User **Process Sheet** Customer CU-DAR001 Dart Helicopters Services **Drawing Name** : ARM : 35296-13 Job Number : 12882 **Estimate Number** P.O. Number Part Number : D3560042 : 22/10/2007 S.O. No. : This Issue **Drawing Number** - D3560 LIND Prsht Rev. : NC : N/A Project Number First Issue : 11 Type : SMALL /MED FAB : C **Drawing Revision** : 35030 Previous Run Material **Due Date** : 29/10/2007 Written By Qty: Each Checked & Approved By Comment 07.05.24 : Est Rev:A EC est rev B ECN 987 07.10.09 EC verified by: DD Additional Product Job Number: Seq. #: Machine Or Operation: Description: 1.0 M6061T6B0500X05000 6061-T6 Bar .50" x 5.0" Comment: Qty.: 1.4648 f(s)/Unit Total: 20.5065 f(s) 6061-T6 Bar 0.50" x 5.00" V 02/11/30 Batch: M/06/82 2.0 BAND SAW Comment: BAND SAW Cut blanks 16.750" long 3.0 HAAS1 Comment: HAAS CNC VERTICAL MACHINING #1 1- Mill as per Folio FA694 Rev: & Dwg D3560 Rev: \_\_\_\_ 2-C'sink 0.196" hole on manual mill as per dwg D3560 3-Deburr per dwg D3560 4.0 QC2 INSPECT PARTS AS THEY COME OFF MACHINE

ARM WELDMENT 1.4

**Subject:** RE: D3560-044 & -042 Cracking

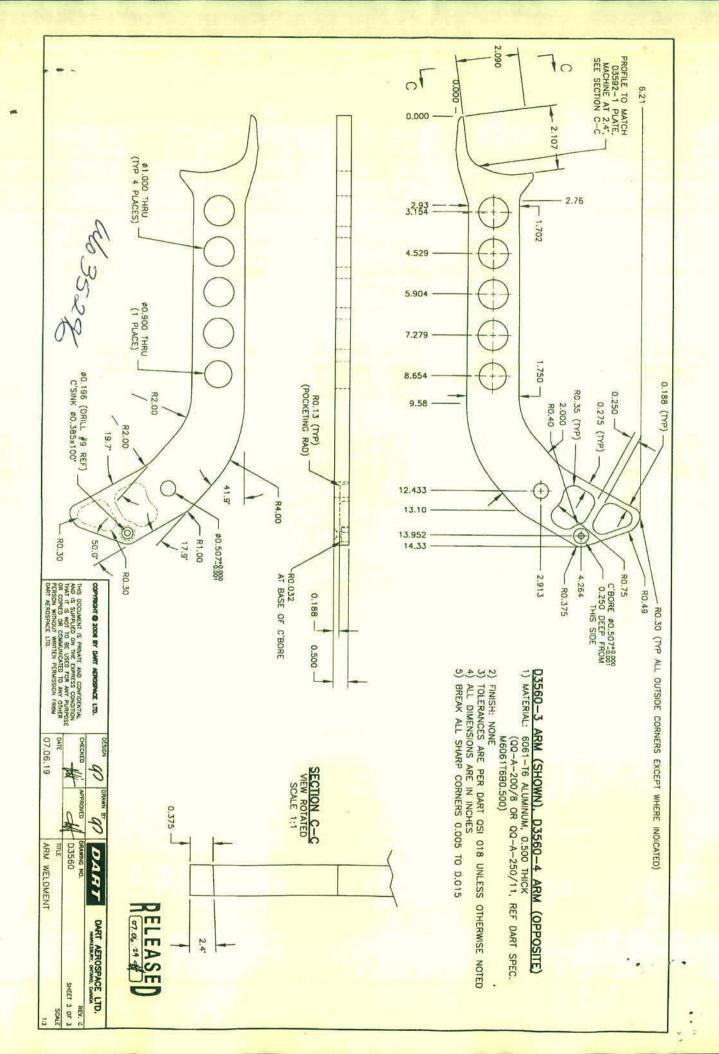
I am not comfortable with any sort of repair to these parts.

I think that all 14 parts should be scrapped.

And, at the risk of stating the obvious, we need to revisit the manufacturing process of this joint.

My preference, as it was a couple of years ago, is to eliminate this weld.

However, the geometry in that area is a little tricky. Suggest we generate an NCR or PAR or whatever.

We have 13x D3560-044 and 1x D3560-042 that have cracks all but 1 in the same location. Attached image D3560-044 Crack 1 shows where 13 of the 14 cracks occurred. D3560-044 Crack 2 shows where the other crack occurred. The cracks shown in D3560-044 Crack 1 vary in depth from roughly 3/32 to ½ inch. I discussed this with Chris and Peter the consensus opinion is the parts are scarp. Further discussion with Chris indicates that changing grain direction to 45 degree on the sheet metal part may lower the scrap rate but not eliminate it. This has been done on a previous deviation with a less scrap. D3560-044 Crack 2 appears to just be an anomaly.
